HISTORIC AND DESIGN REVIEW COMMISSION

April 07, 2021

HDRC CASE NO: 2021-133
ADDRESS: 520 LEIGH ST
LEGAL DESCRIPTION: NCB 2739 BLK LOT 4F & PT OF 5F (AKA TRACT 6)
ZONING: IDZ,H
CITY COUNCIL DIST.: 1
DISTRICT: Lavaca Historic District
APPLICANT: Scott Jones/LABOR STREET COMMONS LLC
OWNER: Scott Jones/LABOR STREET COMMONS LLC
TYPE OF WORK: Construction of a multistory residential structure, site modifications
APPLICATION RECEIVED: March 17, 2021
60-DAY REVIEW: Not applicable due to City Council Emergency Orders
CASE MANAGER: Stephanie Phillips

The applicant is requesting a Certificate of Appropriateness to construct a new 2-story single family residence at the lot addressed 520 Leigh St.

4 **Standalone Residence-North Elevation**
3/16" = 1'-0"

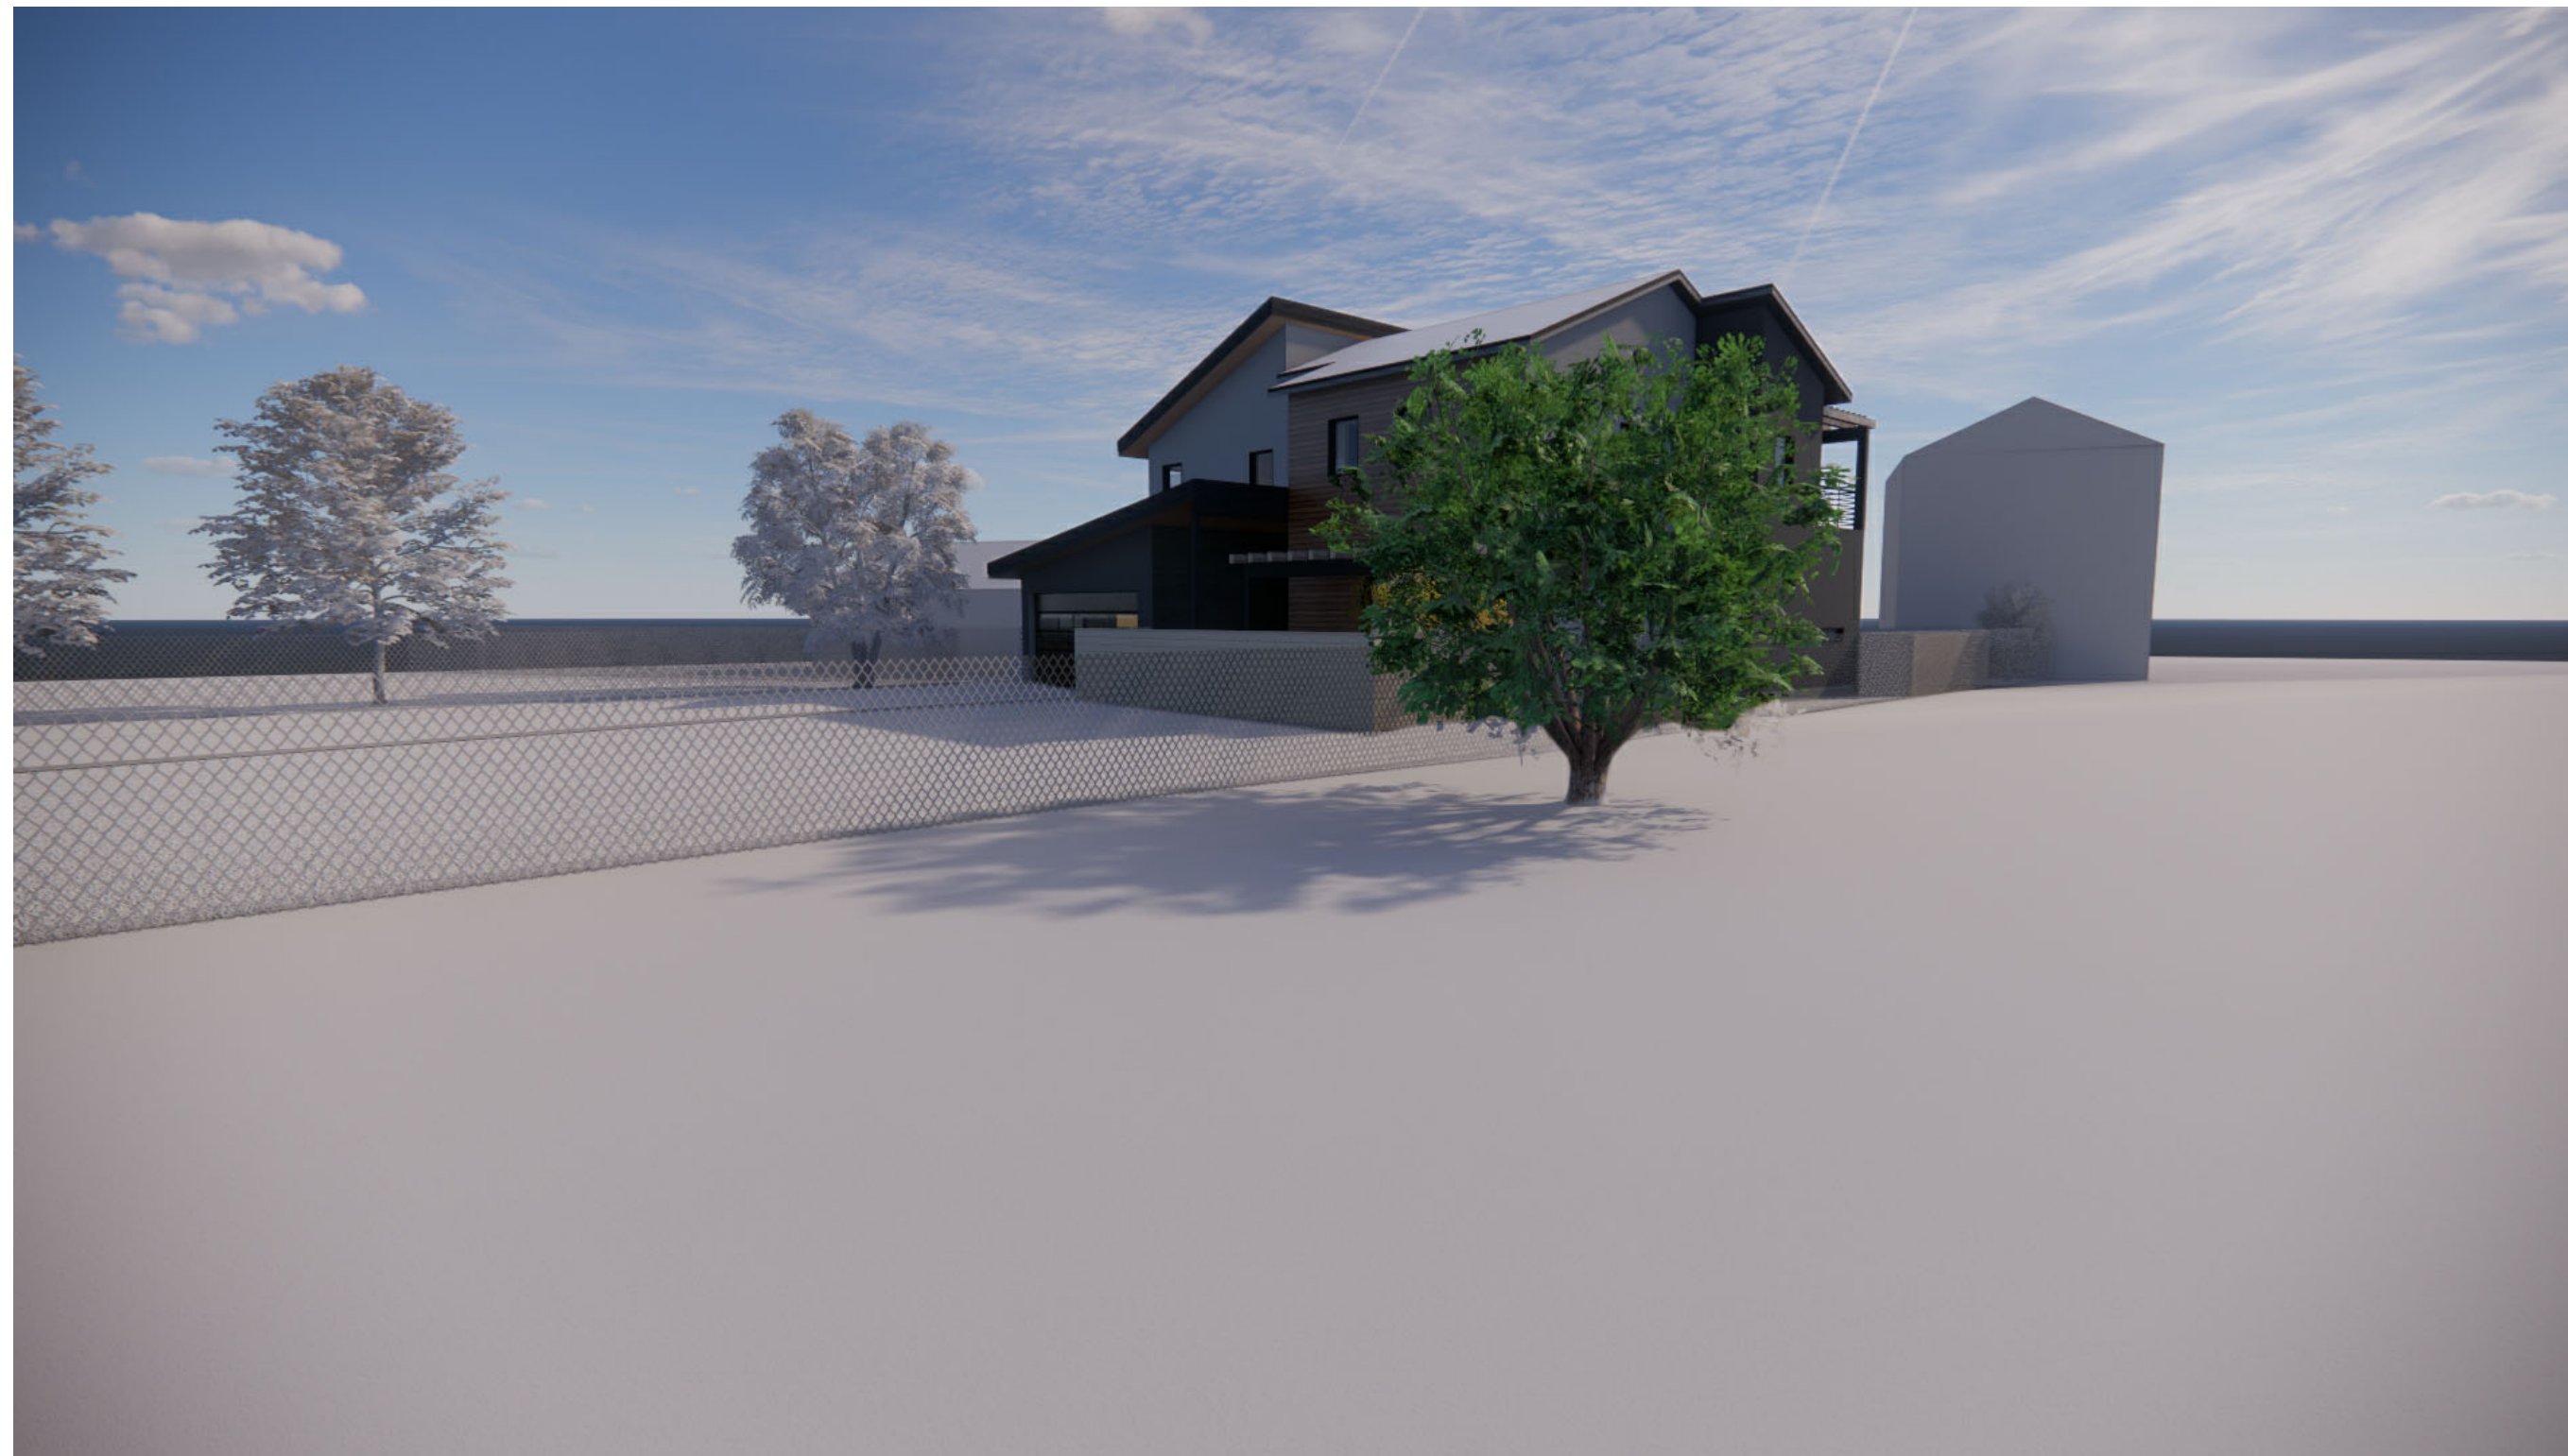
- j. FOUNDATION & FLOOR HEIGHTS – Per the Guidelines for New Construction 2.A.iii., applicants should align foundation and floor-to-floor heights within one foot of floor-to-floor heights on adjacent historic structures. Based on the submitted elevations, the proposed foundation is slab-on-grade with a minimal rise. Staff finds that the applicant should utilize foundation heights that are consistent with the Guidelines.

- k. ROOF FORMS – The applicant has proposed a multi-slope roofline. The primary roofline is a side gable with a low-sloping shed roof extending to the north. . Staff generally finds these roof forms to be consistent based on the surrounding context, but finds that in context with the proportions of the home, additional roof solutions should be explored to visually reduce the mass of the flat roof portion, primarily on the north and east elevations.

- l. WINDOW & DOOR OPENINGS – Per the Guidelines for New Construction 2.C.i., window and door openings with similar proportions of wall to window space as typical with nearby historic facades should be incorporated into new construction. Per the elevations that the applicant has submitted, staff finds the proposed windows to be inconsistent with the Guidelines. The proposed sizes, configurations, and rhythm are not found historically within the district.

- p. WINDOW MATERIALS – The applicant has proposed aluminum clad wood windows, which may be consistent with staff’s stipulations. However, the proposed windows in terms of pattern, detailing, configuration, proportion, and inset are not consistent with the Guidelines.

- i. That the proposed structure be reduced in height and massing to be consistent with rear accessory structures found historically within the district (subordinate to primary structures), as noted in findings f and g.
- ii. That the applicant utilize foundation heights that are consistent with the Guidelines, as noted in finding i.
- iii. That the applicant incorporate roof forms that are more consistent with the surrounding historic context as noted in finding j.
- iv. That the applicant incorporate appropriate traditional window sizes and proportions and modify the overall fenestration pattern as noted in finding k.
